**DOCUMENT 00 90 00
ADDENDUM**

ADDENDUM NO. [1] Date: February 16, 2021

**RE: WESTERN TECHNICAL COLLEGE
 SPARTA PUBLIC SAFETY EXPANSION
 11177 COUNTY HWY A
 SPARTA, WISCONSIN 54656
 HSR PROJECT NO. 20028**

FROM: HSR Associates, Inc
 100 Milwaukee Street
 La Crosse, WI 54603
 (608) 784-1830

3 SECTION @ AHU-4
1/8" = 1'-0"

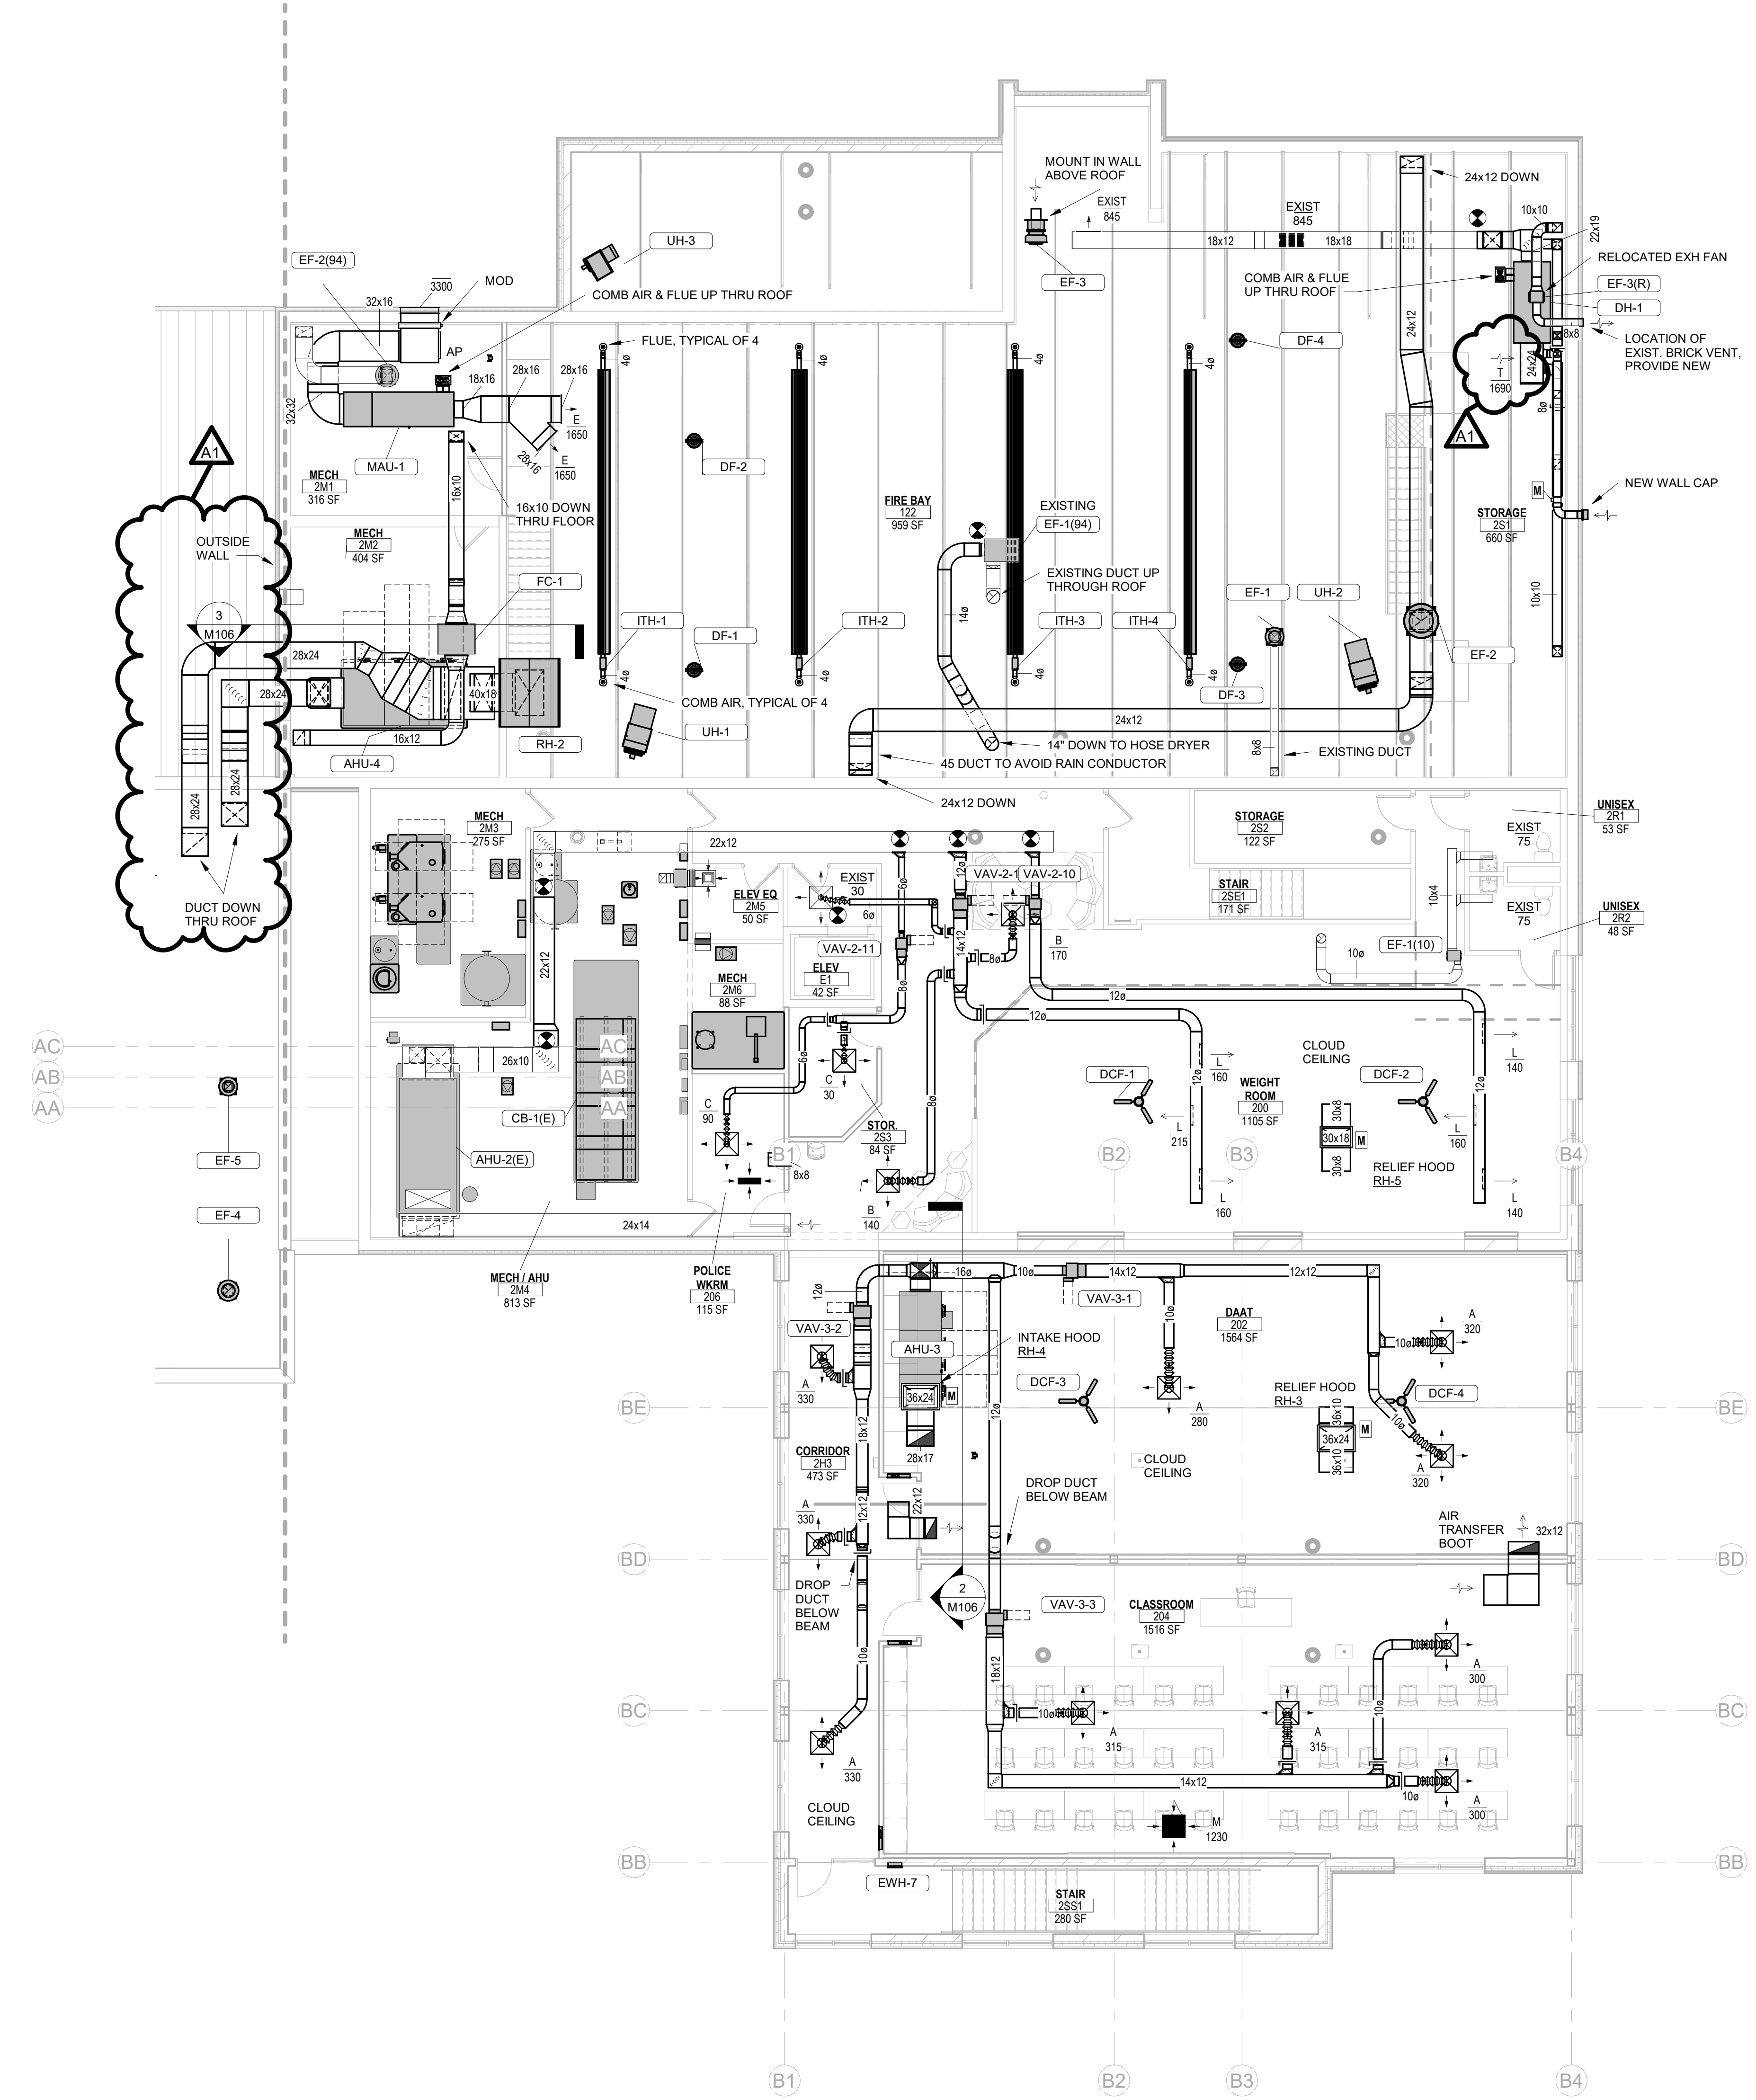
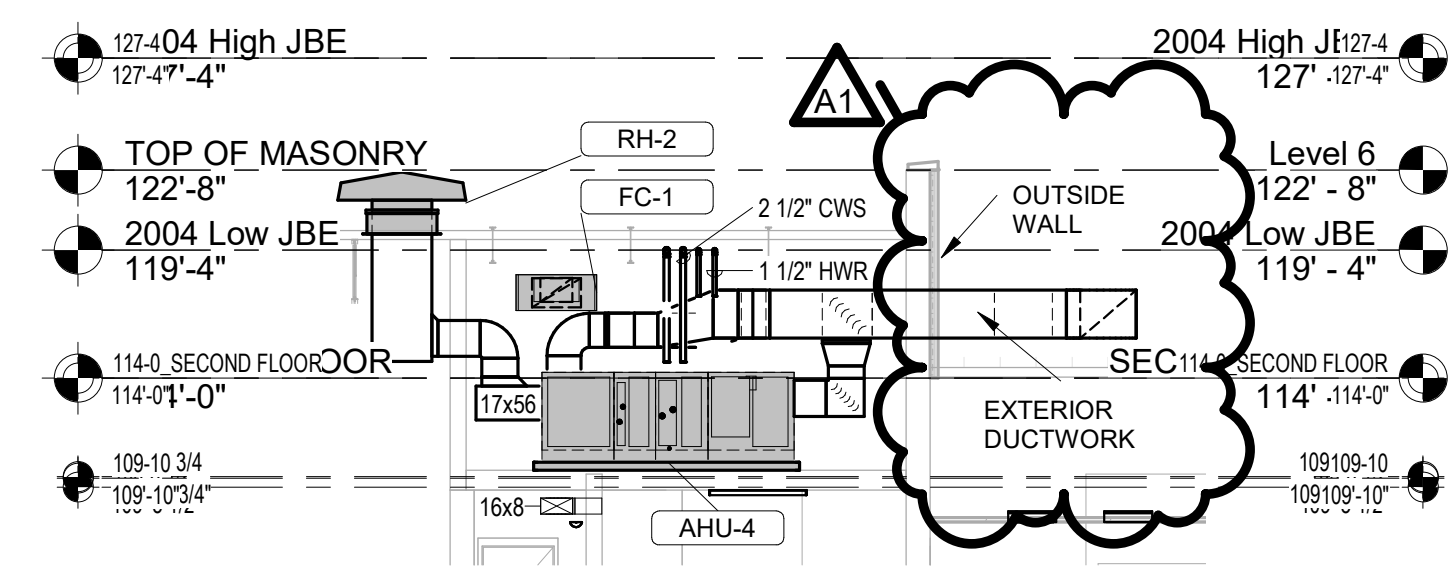
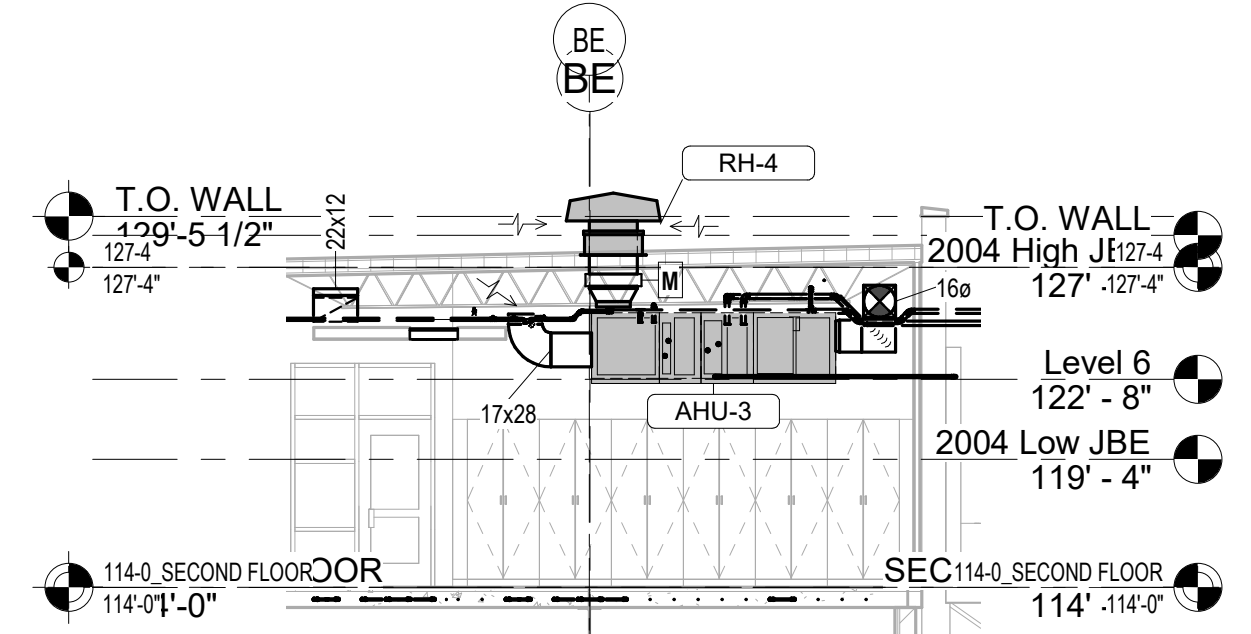
- a. Revisions clouded on Drawing
 - b. Added return grille “T” to DH-1 return duct.
 - c. Clarified location of ductwork exposed outdoors on AHU-4.
27. Sheet M600 HVAC SCHEDULES 30 x 42 attached hereto

1 FIRST FLOOR POWER PLAN - AREA A
SCALE: 1/8" = 1'-0"
20-07-E-PP01

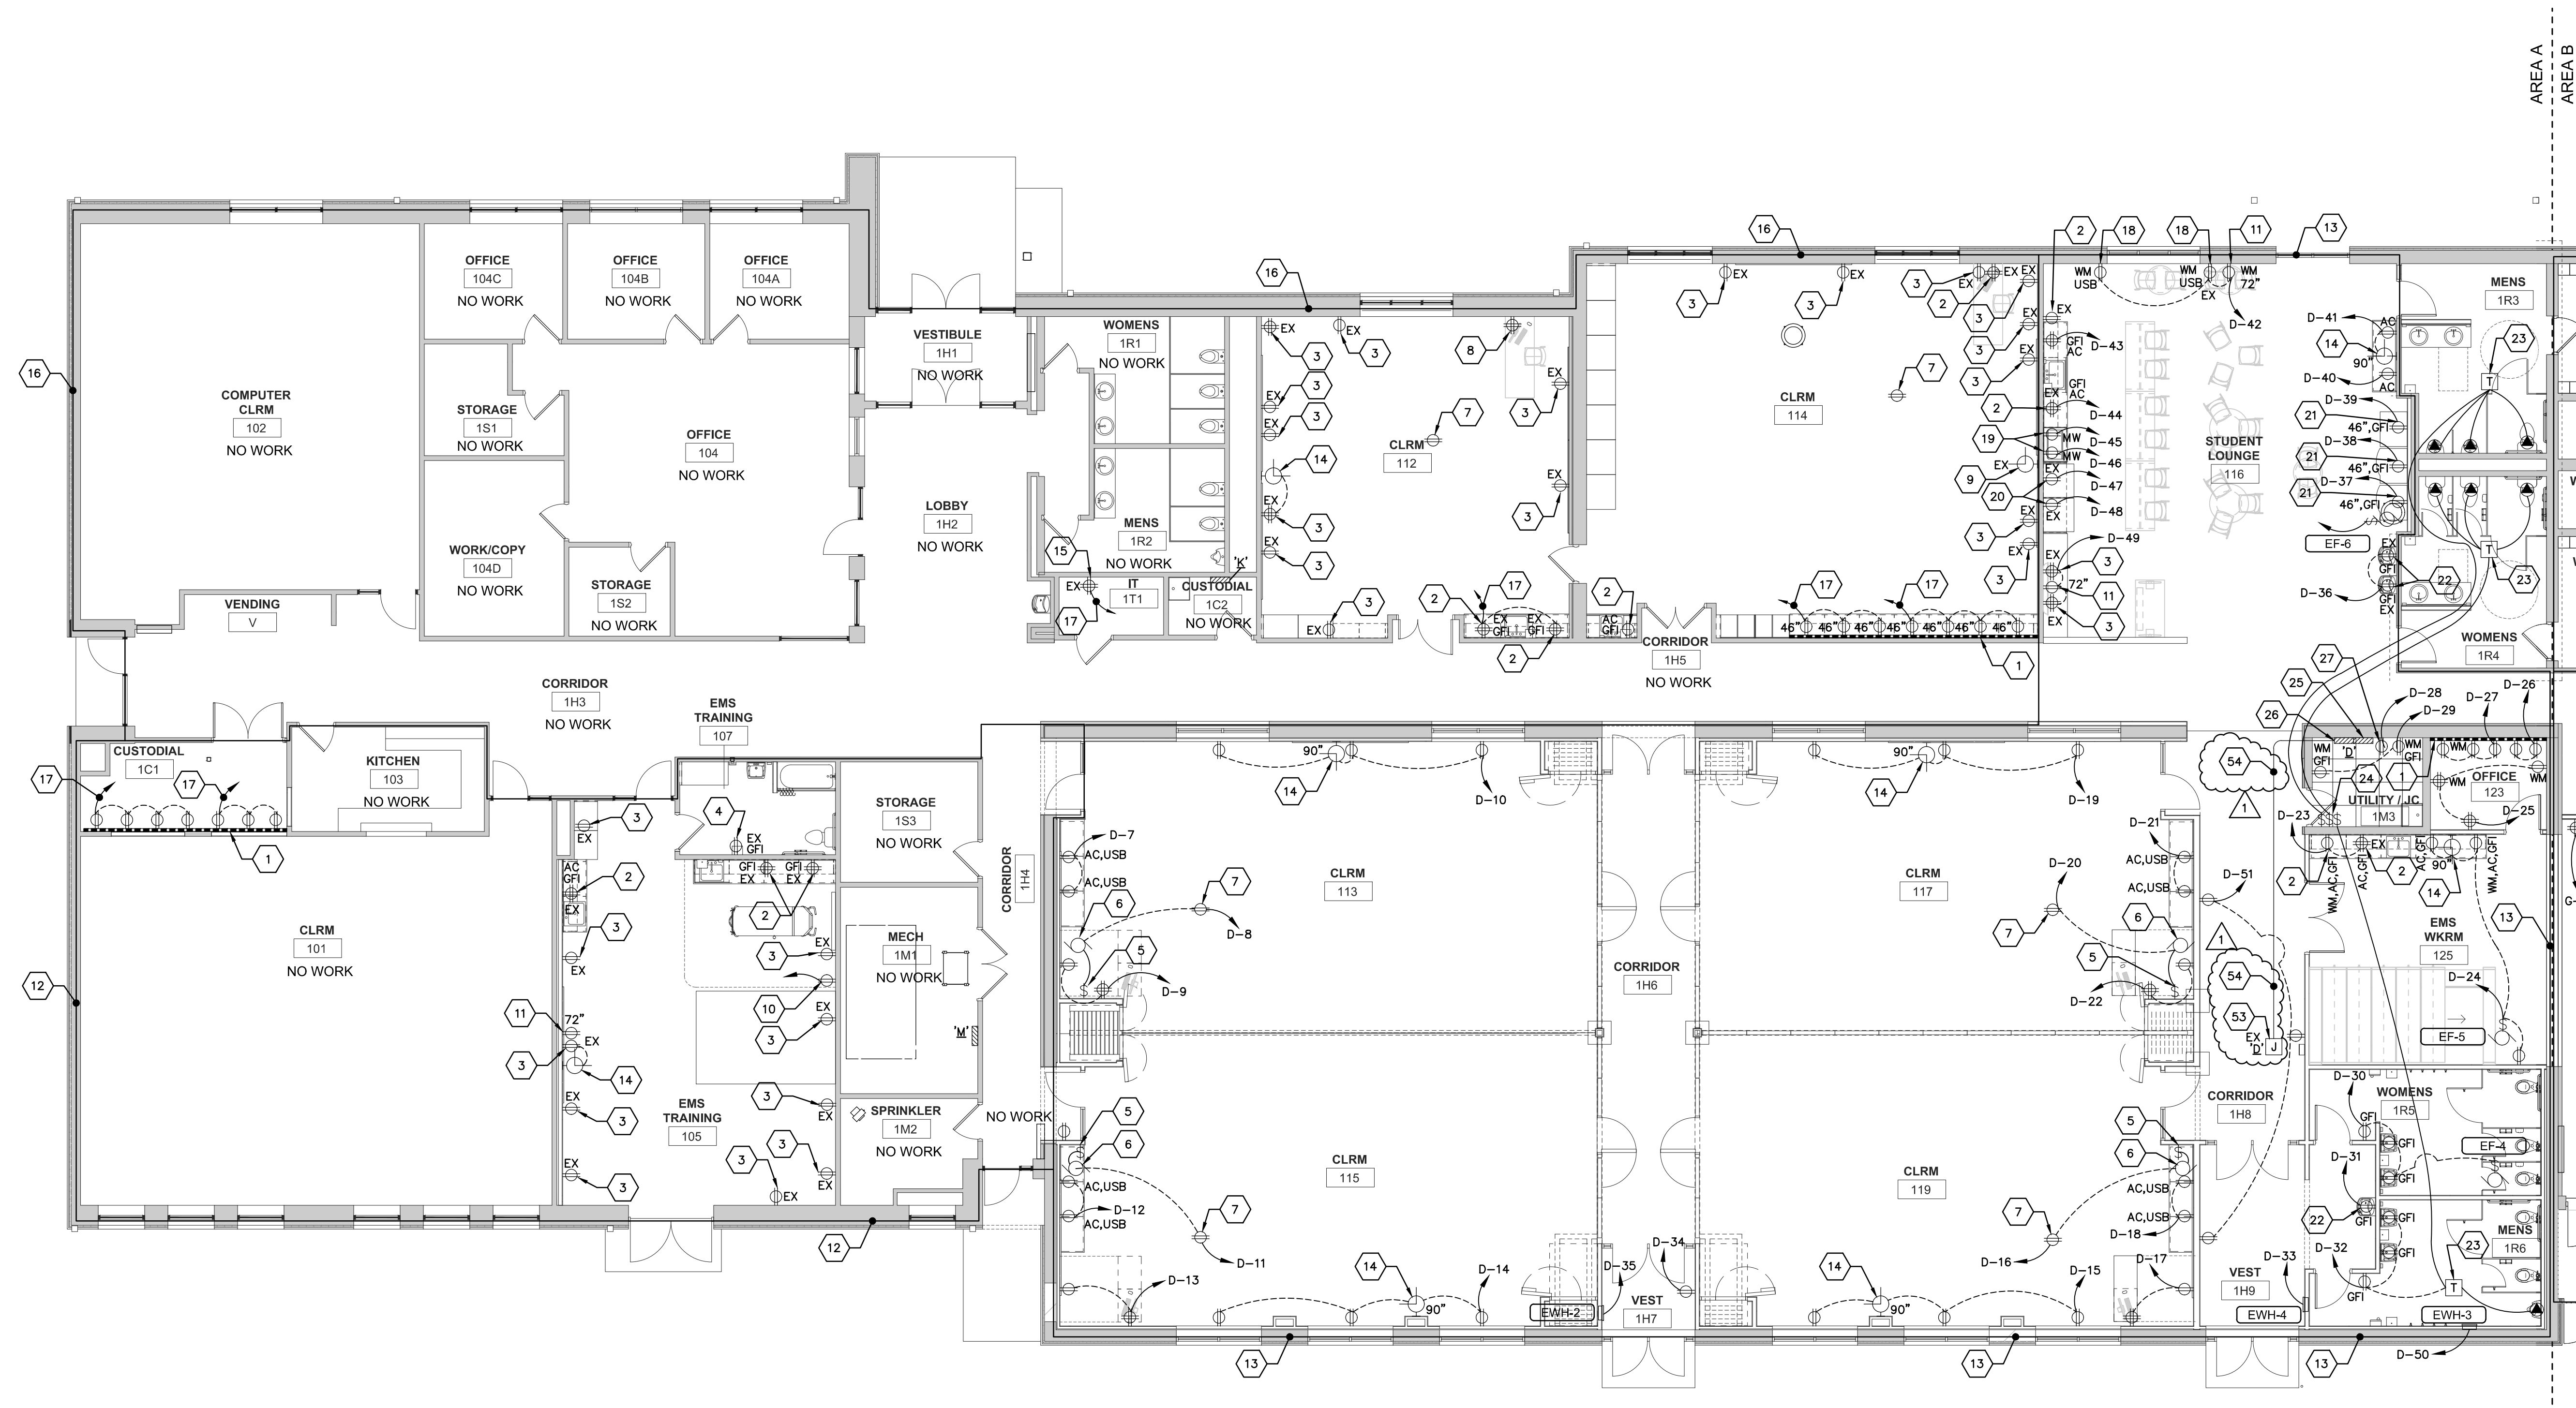
- a. Revisions clouded on Drawing.
 - b. In Corridor #1H8, added missing keyed notes #53 and #54 for Panelboard ‘D’ feeder. Refer to clouded changes dated 2-15-2021.
